Product Change Notification

106481 - 00

Change Notification #: 106481 - 00
Change Title: AXCMA3U7U, PCN 106481-00, Product Design, Class 2, Improvements to Cable Management Arm design
Date of Publication: June 27, 2006

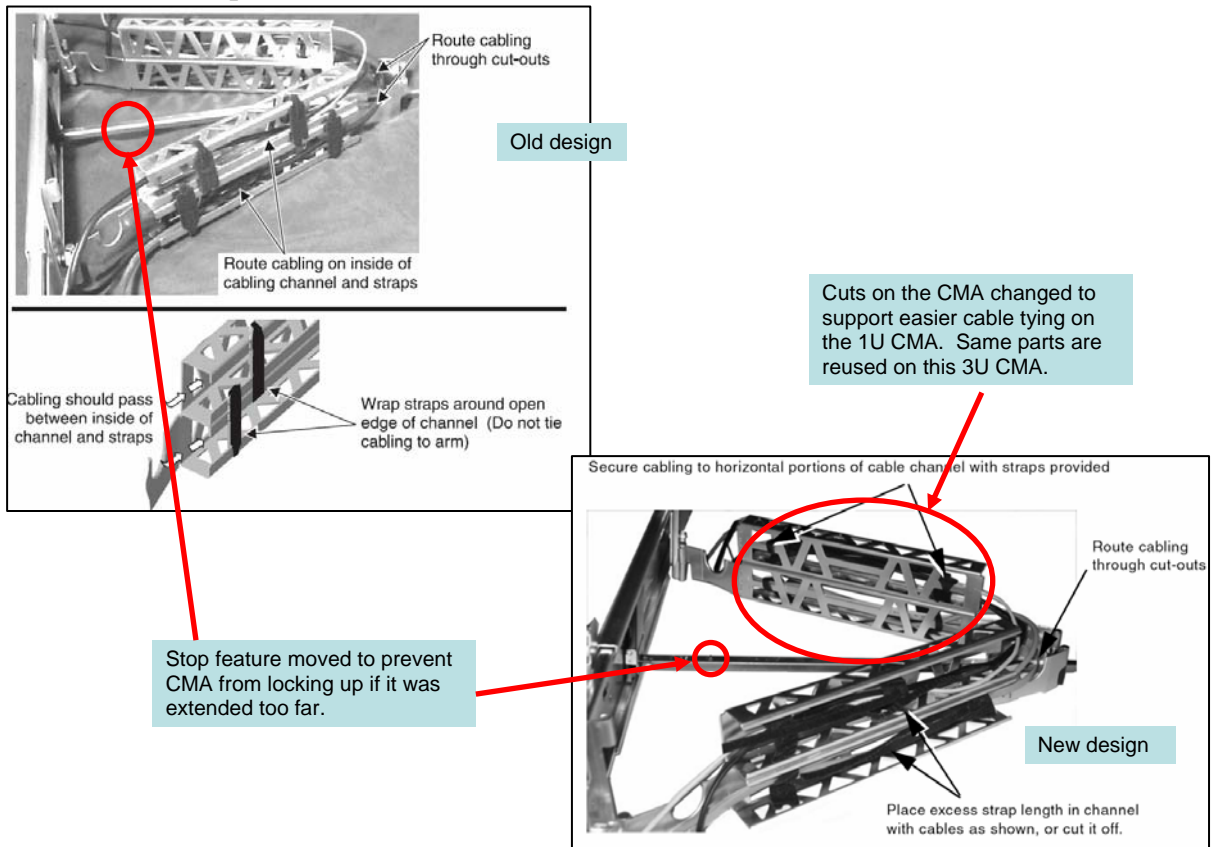
Change #1: Stop feature moved to prevent CMA from locking up if it was extended too far.

Change #2: Cuts on the CMA changed to support easier cable tying on the 1U CMA. Same parts are reused on this 3U CMA.
